M24C64T-FCU package mechanical data modifications

This errata sheet applies to the M24C64T-FCU, that is the 64 Kbit serial I²C bus EEPROM delivered in WLCSP four balls.

The impacted part number is M24C64T-FCU6T/TF.

Figure 2. D and E front side view

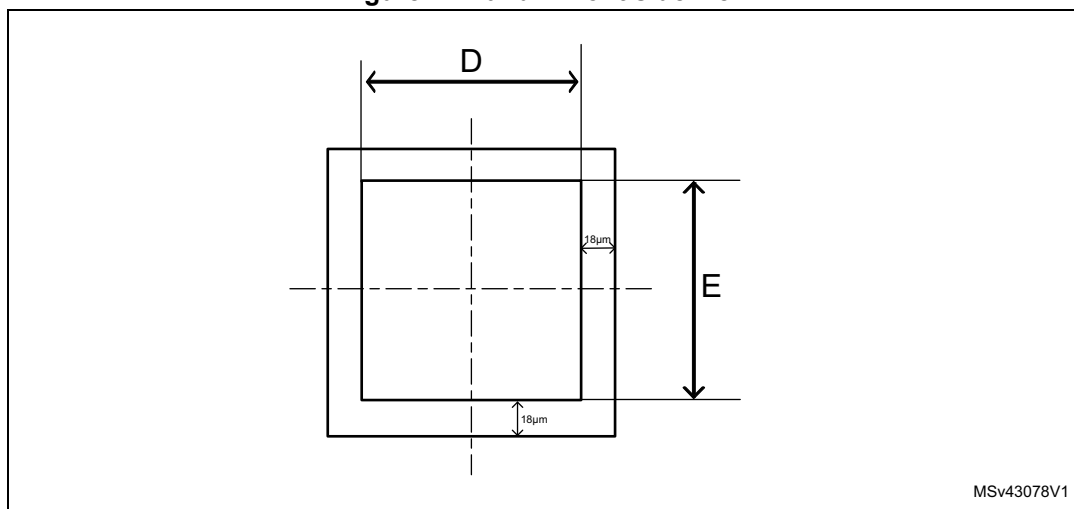
- The D and E values on M24C64T-FCU datasheet correspond to front side view (ball side), instead of back side view (marking side view).
[Table 1](#) and [Table 2](#) report the data for the front and back view, respectively.

Symbol	Millimeters			Inches		
	Min	Typ	Max	Min	Typ	Max
D	-	0.833	0.853	-	0.0328	0.0336
E	-	0.833	0.853	-	0.0328	0.0336

Figure 3. D and E back side view

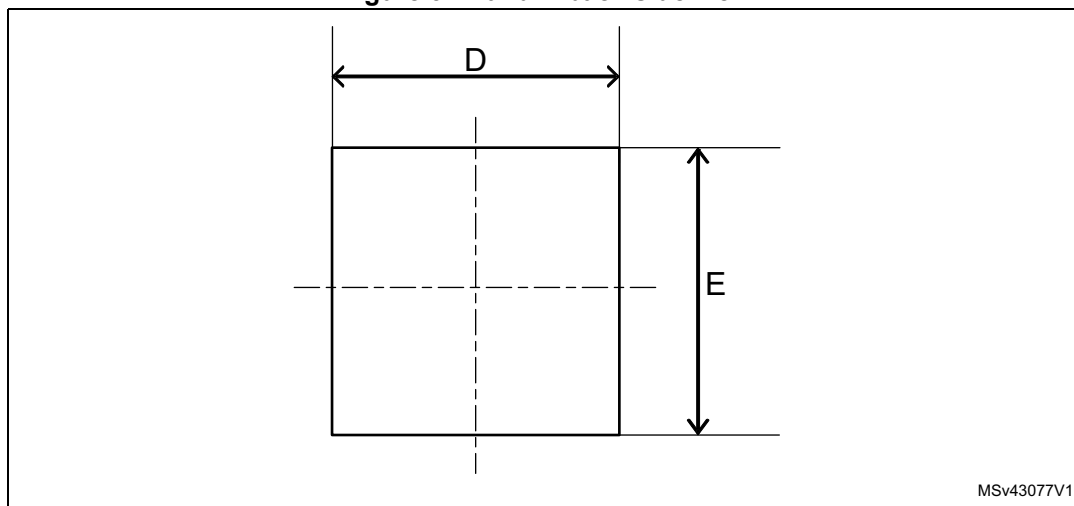
This document refers to the changes of dimensions D and E (see [Figure 3](#)) described in the M24C64T-FCU datasheet, in tables detailing the dimensions of the Ultra Thin WLCSP 4-bump package.

D and E values must be modified to correct the following mistake:

Symbol	Millimeters			Inches		
	Min	Typ	Max	Min	Typ	Max
D	0.831	0.851	0.871	0.0327	0.0335	0.0343
E	0.831	0.851	0.871	0.0327	0.0335	0.0343

Figure 4. D or E side view

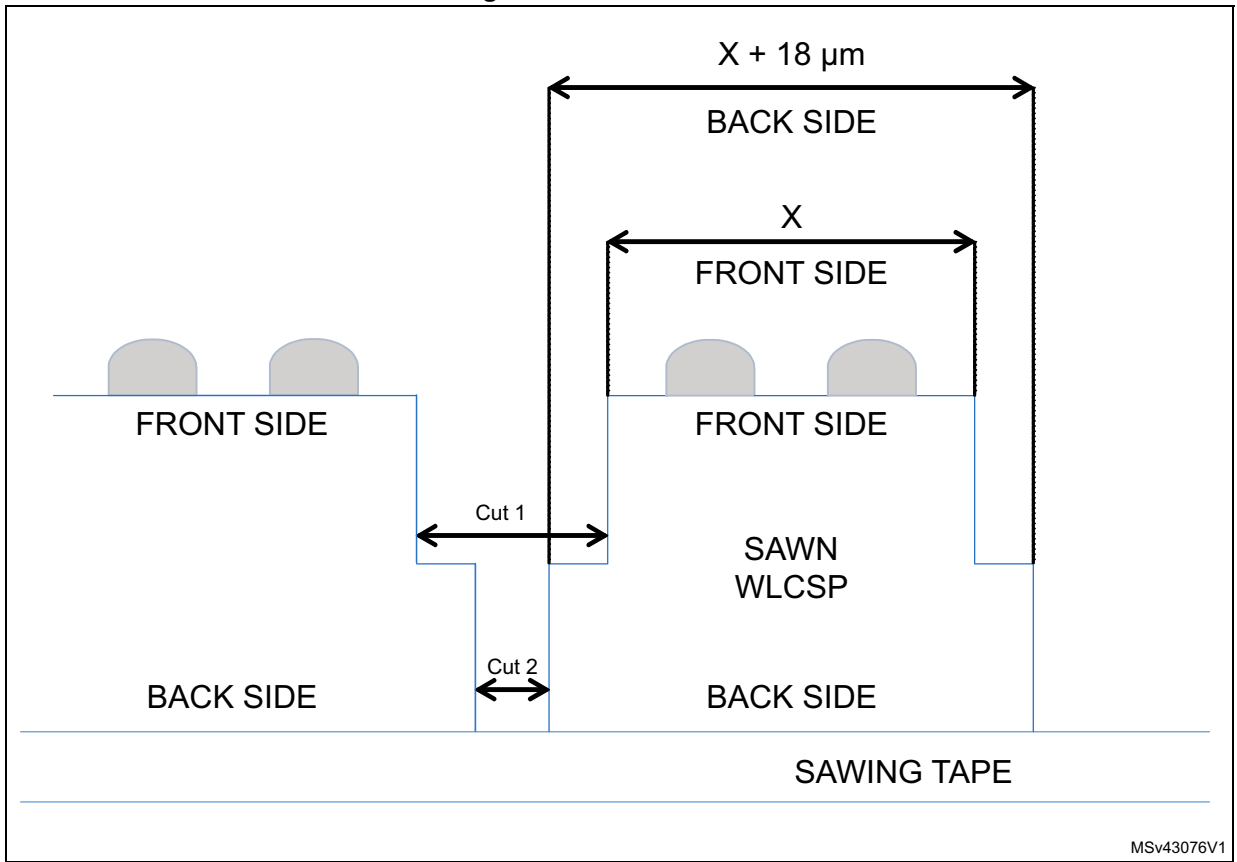
The difference between back side and front side dimension is 18 μm (0.018 mm). This difference is due to two-step sawing process, where cut 1 and cut 2 are performed with blades having different thickness (see [Figure 4](#) in which X represents D or E and it has the same value and tolerance).
